Comments on the Planning Applications

for the redevelopment of the former Stag Brewery

Mortlake

Re-consultation on revised documents

1. Building Heights, Massing, Density

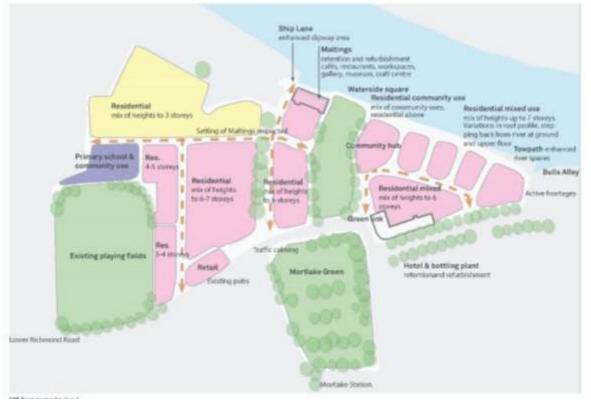
The Planning Brief for the site (see below) indicated building heights as follows:

- 1. Mix of heights up to 7 storeys along the riverside stepping back from the river at ground level and upper floor levels, so that the height diminishes towards the site perimeter;
- 2. Mix of heights to 6 storeys along Mortlake High Street and Lower Richmond Road to Ship Lane;
- 3. Mix of heights to 6-7 storeys from Ship Lane to the existing main entrance off Lower Richmond Road;
- 4. 3-4 storeys from the main entrance to the playing fields and 4-5 storeys further north;
- 5. 3 storeys to the south of Thames Bank.

The submission approved by the Richmond Council Planning Committee in January, referred to as the original scheme (see next page), did not comply with the Planning Brief in the following regard: no stepping back of the upper floors in Area 1, a 7-storey element in Area 3, a 6-storey element in Area 4 and a 4-storey element in Area 5.

The latest scheme (also on next page) shows 8, 9 and 10-storey elements in Area 1, 8-storey elements in Area 3, 7-storey elements in Area 4 and the replacement of 3-storey with 4- and 6-storey elements in Area 5.

In the Planning Brief the building heights were imposed in order to keep the density and impact on traffic within reasonable limits (as well as minimising any impact on the locally listed 8-storey Maltings and the statutorily listed houses along Thames Bank – see Section 2 below). The latest scheme, with its significant increases in height, has flagrantly breached the guidance in the Planning Brief (see next page following).

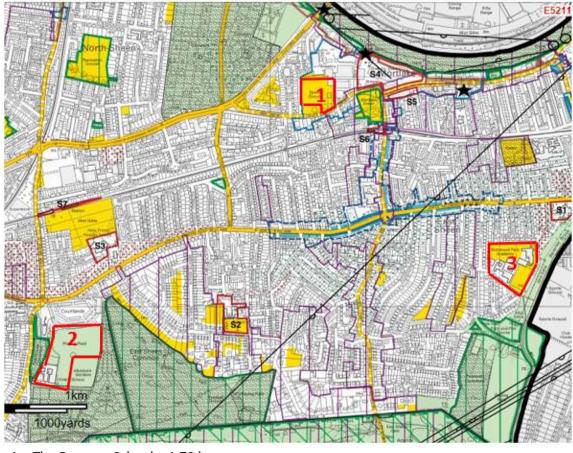
As for the Council's decision to locate the school on the Brewery site we are of the opinion that, in accordance with Policy 3.18D of the Current London Plan, there are demonstrable negative local impacts which substantially outweigh the desirability of establishing a new school on this site, in particular:

- The site is very cramped its area is one third of the area prescribed by the DfE for a 6-form entry plus 6th form secondary school and is not likely to be acceptable in the post-COVID era;
- The only access to the site is that seen here (below) off Lower Richmond Road which is gridlocked between the choked Chalker's Corner junction and the shambolic Sheen Lane level crossing;
- The development will entail loss of the much treasured grass playing fields and their replacement with an all-weather pitch, fenced in and floodlit;
- Most importantly the development of another school in this area will create problems for the existing secondary schools which are currently struggling to achieve viable 6th forms.

Christ's School

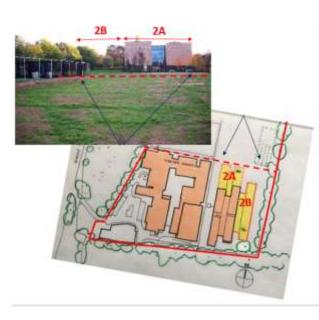
Christ's School Expansion from 5FE to 6FE?

New 6th form block (pp granted in 2013) within small pocket of MOL which is vast and includes playing fields, allotments, cemetery, etc.

Opportunity to achieve 6FE by - expanding 6th form block further north to building line shown dashed

- building new wing to east.

Extension of both wings of new 2-storey block as far as the building line of the existing main block will represent further encroachment into the MOL, but only very slight.

Development of new 2-storey wing on left-over strip of land on east side will in effect fill out the pocket of MOL but the land does not appear to be used and the impact would again be very slight. Trees to east and south will not be touched.

Richmond Park Academy

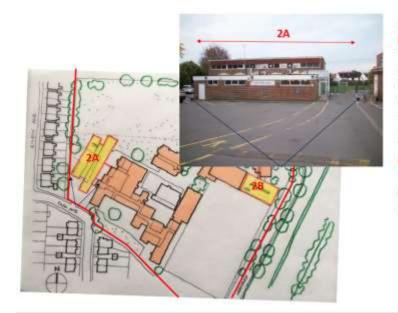
Expansion from 6FE to 8FE?

Expansion to accommodate 6th form has been fragmented (pp granted in 2012).

Opportunity to achieve 8FE by - building new 6th form block in place of <u>Shene</u> Fitness Centre - building to east of sports hall fronting Hertford Avenue. The existing all-weather pitch can sustain the increase.

The new 6th form block in the style of that recently built at Christ's will cover the same ground as the Fitness Centre including its carpark and will minimise any encroachment onto the grass playing field (OOLTI).

There is potential here for a new 2storey block which could conceivably even rise to 3 storeys.
